# Access Compliance Report

## Public Rights-of-Way

### (Curb Ramps)

Intersection ID: 17836	Main Street: NORMANDY_RD	Cross Street: PENDER_PL	Location: NE
ADA ID: 2DEB4B3D760B	Ramp Type: PerpDiag	Initial Pass/Fail: Fail	Overall Compliance: No
Severity Score: 22.5			
Codes/Mitigation Info/Possible Solution		Field Measurements/Component Compliance

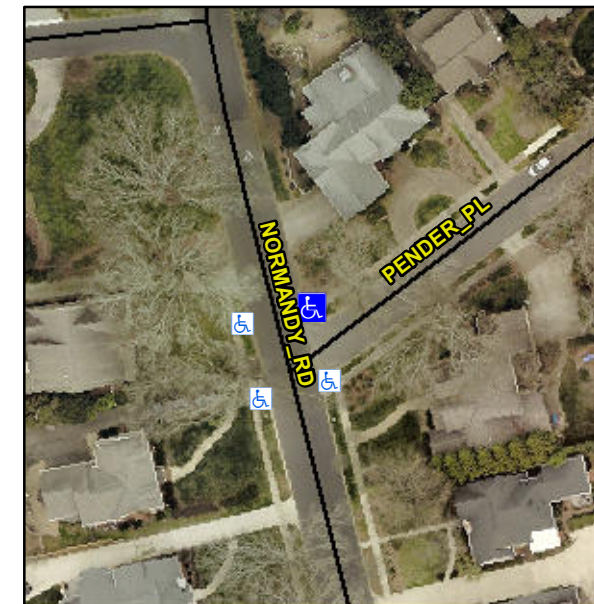
**Not Found, R304.5.1, R304.2.2, R304.5.3**

Compliance	Description	Data	Compliance	Description	Data
N/A	Ramp Length (in)	61.0	No	Ramp Slope (%)	8.4
No	Ramp Width (in)	47.0	No	Ramp XSlope (%)	2.7
N/A	Flare Type LT	N/A	N/A	Flare Type RT	N/A
N/A	Flare Slope LT (%)	N/A	N/A	Flare Slope RT (%)	N/A
N/A	Flare Traversable LT?	N/A	N/A	Flare Traversable RT?	N/A
N/A	Landing Length (in)	N/A	N/A	DWS Provided?	N/A
N/A	Landing Width (in)	N/A	N/A	DWS Contrast?	N/A
N/A	Landing Slope (%)	N/A	N/A	DWS Length (in)	N/A
N/A	Landing X Slope (%)	N/A	N/A	DWS Full Width?	N/A
N/A	Landing Curb? (Y/N)	N/A	N/A	DWS Offset (in)	N/A
N/A	Shared Landing?	N/A			
N/A	Gutter Ponding?	N/A	N/A	Gutter Slope (%)	N/A
N/A	Gutter Lip Ht (in)	N/A	N/A	Gutter X Slope (%)	N/A
N/A	Painted X Walk1?	No	N/A	Painted X Walk2?	No
	X Walk 1 Direction	To W		X Walk 2 Direction	To S
N/A	X Walk 1 Width (in)	N/A	N/A	X Walk 2 Width (in)	N/A
	X Walk 1 Slope (%)	8.2		X Walk 2 Slope (%)	1.8
	X Walk 1 X Slope (%)	6.5		X Walk 2 X Slope (%)	0.7

**Remove & Replace Curb Ramp With Two New Directional Ramps or Equivalent.**
